Form 3 160-5

BUREAU OF LAND MANAGEMENT SUNDRY NOTICES AND REPORTS ON WELLS Do not use this form for proposals to drill or to deepen or reentry to a different reservoir. Use "APPLICATION FOR PERMIT—" for such proposals SUBMIT IN TRIPLICA TE 1 Type of Well SUBMIT IN TRIPLICA TE 1 Type of Well Other 2 Name of Operator CONOCO INC. 3 Address and Telephone No 10 DESTA DR. STE. 100W, MIDLAND, TX. 79705-4500 (915) 686-5424 4 Location of Well (Footage, Sec., T. R. M. or Survey Description) Section 19, T-20-S, R-35-E, O 660 FSL & 1980 FEL CHECK APPROPRIATE BOX(s) TO INDICATE NATURE OF NOTICE, REPORT, OR OTHER DATA TYPE OF SUBMISSION TO INDICATE NATURE OF NOTICE, REPORT, OR OTHER DATA TYPE OF SUBMISSION Type of Submission (Clearly uses ad permissis (filterly uses ad permissis details, and ave permissed dates, including command date of stating any prepared work if well is derectionally delile give subsurface locations and measured and row versical depths for all markers and zones permisses to this work,)* As per the attached and approved sundry. Conoco proposes to recomplete this well to the Tubb. The externely marginal Blinebry perfs will remain open to the casing and will remain unrecoverab

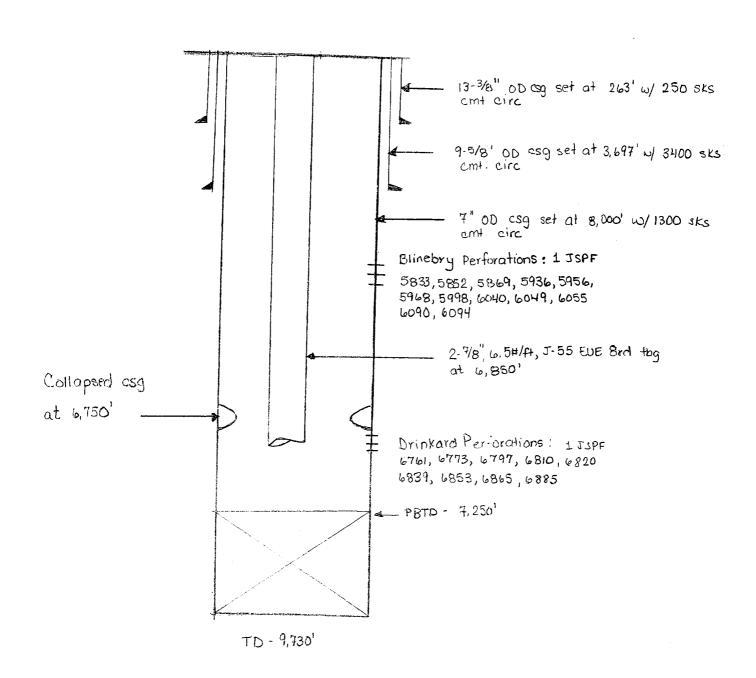
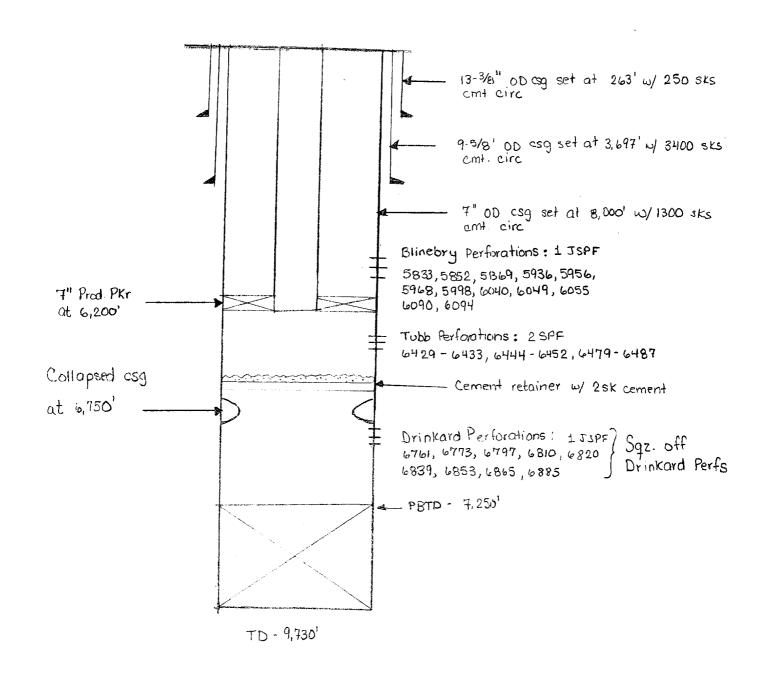
Note: Recompessurated multiplecompition or Recompletion Report and Log form. 13. Describe Proposed or Completed Operations (Clearly state all pertinent details, and give pertinent dates, including estimated date of starting any proposed work. If well is directionally driller give subsurface locations and measured and true vertical depths for all markers and zones pertinent to this work.)* As per the attached and approved sundry, Conoco proposes to recomplete this well to the Tubb. The externely marginal Blinebry perfs will remain open to the casing and will remain unrecoverable while the Tubb reserves are being produced. Please see attached current and proposed wellbore schematics.

13. Describe Proposed or Completed Operations (Clearly state all pertinent details, and give pertinent dates, including estimated date of starting any proposed work. If well is directionally driller give subsurface locations and measured and true vertical depths for all markers and zones pertinent to this work.) As per the attached and approved sundry, Conoco proposes to recomplete this well to the Tubb. The externelly marginal Blinebry perfs will remain open to the casing and will remain unrecoverable while the Tubb reserves are being produced. Please see attached current and proposed wellbore schematics.			_			INcle: Reponresuitsof multiplecompitiononWdl
Marie acel	As per the atta	ached and approved sundry. Conto the casing and will remain	cal depths for all markers	recomplete this w	his work.)* ell to the Tubb. The ϵ	externely marginal Blinebry perfs

Warren Tubb Gas Producer
PROPOSED SCHEMATIC
4/9/2001
